Safety Defect and Noncompliance Report Guide for Vehicles
Part 573 Defect and Noncompliance Report

02V-093

2. The vehicles involved in the recall are model years **2001-2002 NewAire and NewAire Classic, Class A Motorhomes**. Models are the 2801 and 2802. Production dates are from June 4, 2001 to March 15, 2002.

AUSCO TO CARLISLE CHANGE

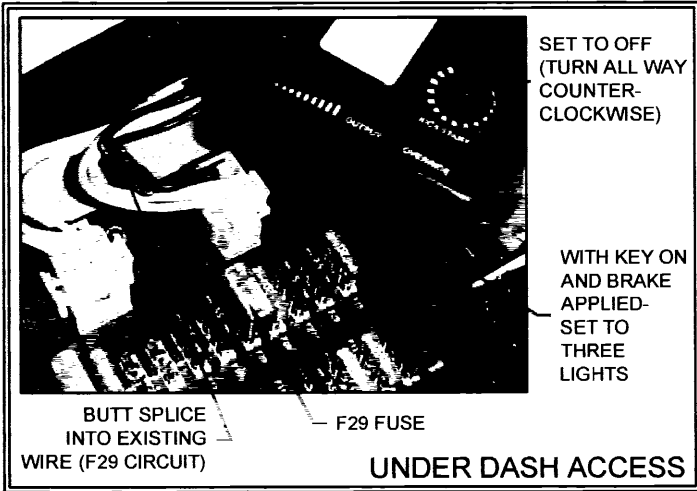
5. The defect relates to an electrohydraulic-braking device manufactured by Ausco. When activated, the master cylinder applies the brakes on the tag axle. This part is found to fail by causing a lock-up, causing the tag axle brakes to hold. If the motorhome is traveling, the tag axle brakes may lock-up causing severe heat and possible fire.

8. Newmar will change the Ausco component to a Carlisle component that will fit our application. The Carlisle component will allow the proper operation of the tag axle brake.
